STAFF REPORT

Re:	<u>Lone Peak Hospit</u>	<u>al Medical Office Building – Site Plan Amendment Request</u>
	Application No.:	2024-0225-SP
	Applicant:	Wesley Blissard, Catalyst Design Group, representing Lone Peak
		Hospital
	Project Location:	11925 S. State Street
	Current Zoning:	CR (Regional Commercial) Zone
	Acreage:	Approximately 35.87 Acres (Approximately 1,562,497 ft ²)
	Request:	Request for approval of a Site Plan Amendment in the CR zone
		regarding the construction of a new medical office building.

EXHIBIT A DEPARTMENT REVIEWS

PHOTOMETRICS - SITE PLAN B - PART G

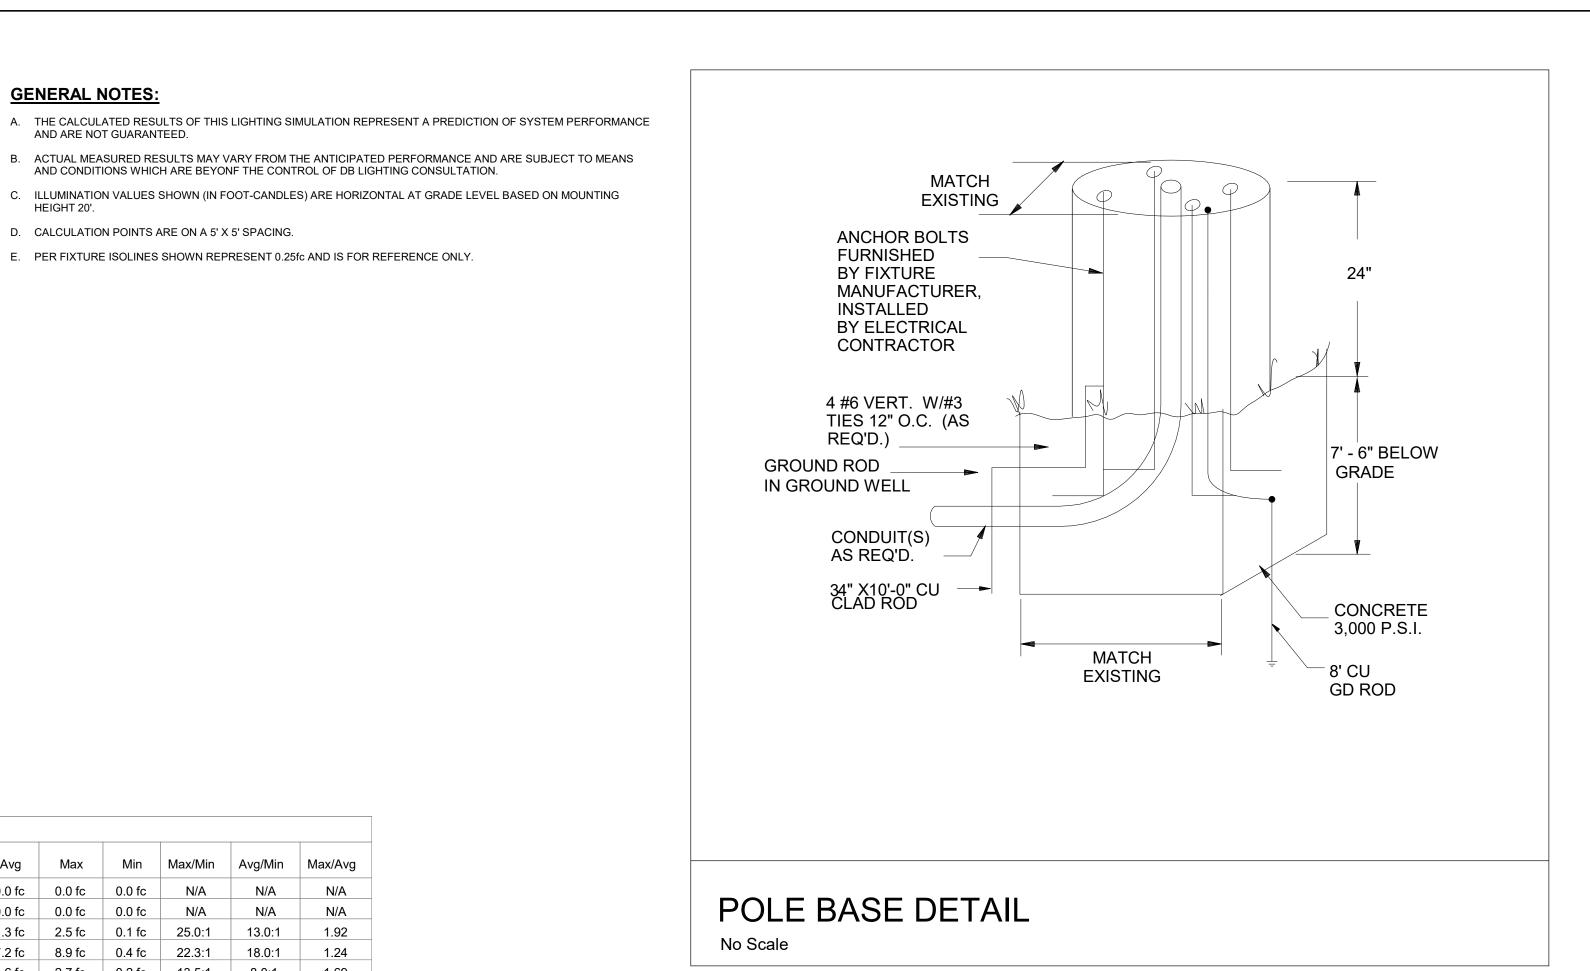
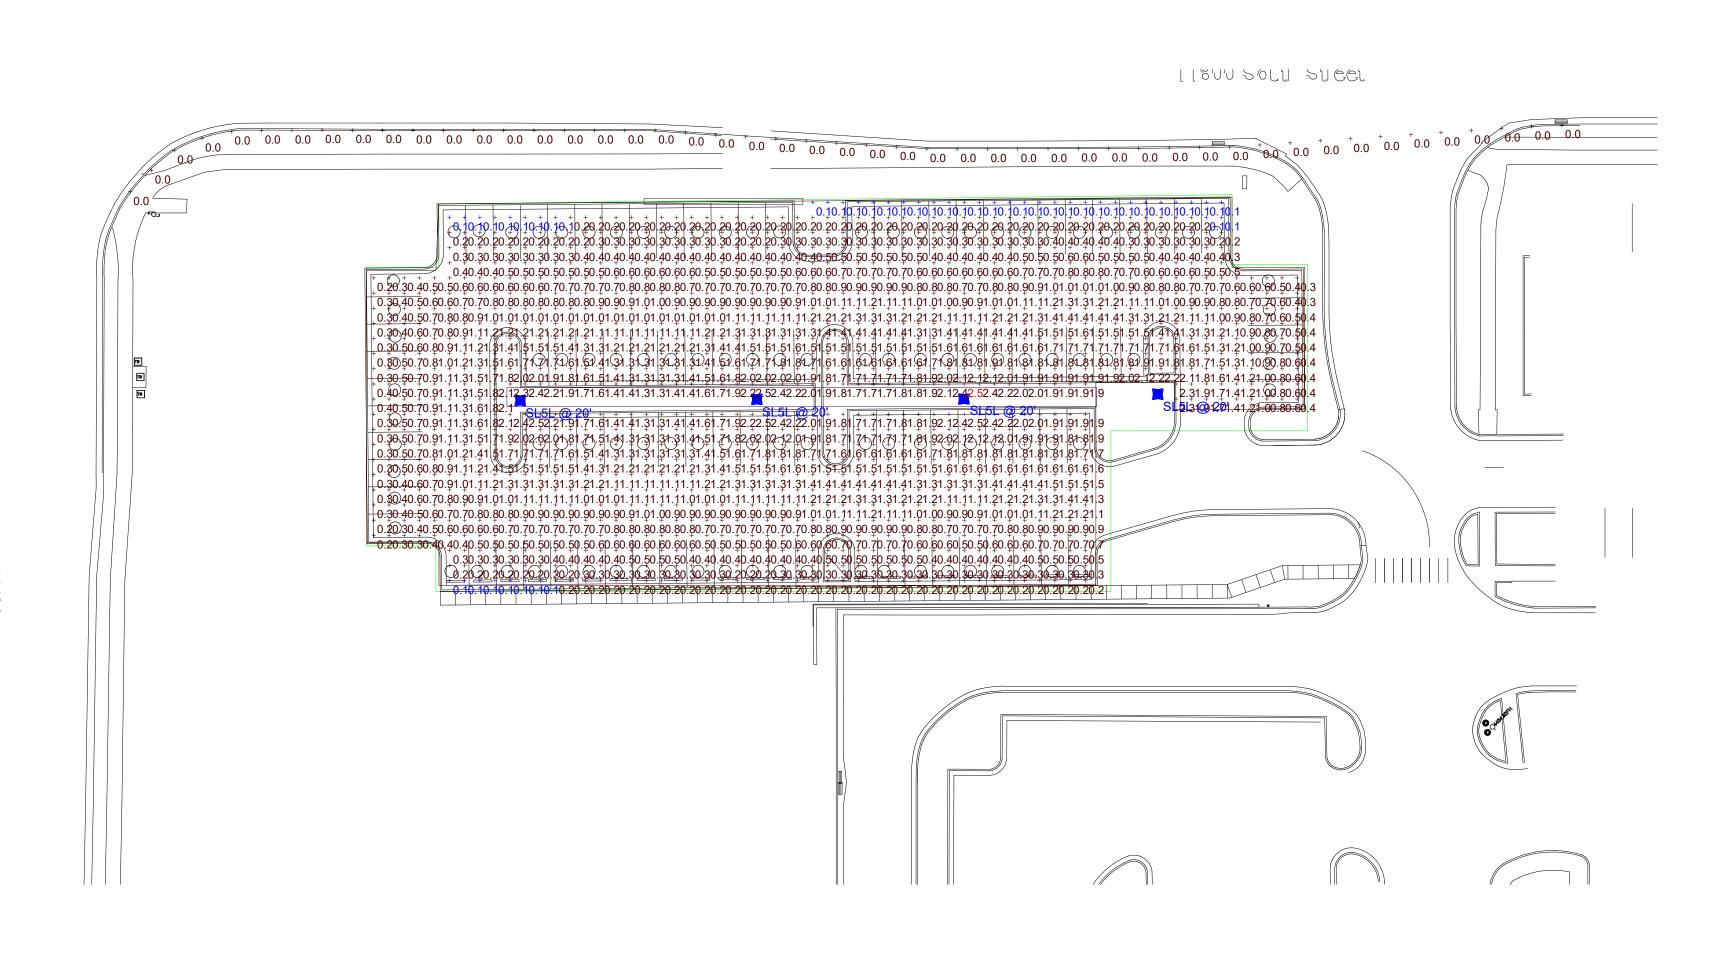
1. SPECIFY THE TYPES, DETAILS AND LOCATION OF EACH LIGHTING FIXTURE IN THE LANDSCAPED AND PARKING AREAS AND ON THE BUILDING FOR REVIEW.

6. ILLUMINATION INTENSITIES: PROVIDE A TABLE SHOWING THE MAXIMUM ILLUMINATION, MAXIMUMAVERAGE ILLUMINATION, AND MAXIMUM ILLUMINATION RATION. THE USE AREAS TO BE SHOWN IN THE TABLE WOULD BE, AT MINIMUM, THE HOSPITAL USE AND THE EXTERIOR SITE BOUNDARY, THOUGH BUILDING AREAS, CANOPIES AND PEDESTRIAN COULD ALSO BE BROKEN OUT.

7. AFTER HOURS INTENSITIES: PROVIDE A TABLE SHOWING THE MAXIMUM ILLUMINATION, MAXIMUM AVERAGE ILLUMINATION AND MAXIMUM ILLUMINATION RATIO IF THE SITE IS NOT OPEN 24 HOURS A DAY.

8. LIGHTING REDUCTION: THE AFTER HOURS LIGHTING PLAN SHALL ALSO DEMONSTRATE A REDUCTION IN THE NUMBER OF LIGHTING SOURCES THAT ARE ON DURING AFTER HOURS TIMES. SPECIFY THAT AT LEAST ONE-THIRD OF THE LIGHTING SOURCES WILL BE TURNED OFF AFTER HOURS.

RESPONSE: POLE LIGHTING IS SPECIFIED AND LOCATIONS ARE SHOWN ON SHEET ES01A AND ES01B. NO LIGHT FIXTURES ARE IN ANY OTHER LANDSCAPED AREA AROUND THE BUILDING. LIGHT FIXTURE TYPES ARE SHOWN ON THE RESPECTIVE SHEETS MENTIONED ABOVE. (CUT SHEETS ARE PROVIDED WITH THE SUBMITTAL FOR REVIEW)

RESPONSE: SEE LIGHTING CALCULATION SCHEDULE SHOWING REQUIRED ELEMENTS.

RESPONSE: THE SITE IS OPEN ALL DAY.

RESPONSE: SEE OPERATION OF LIGHTING CONTROL NOTES.
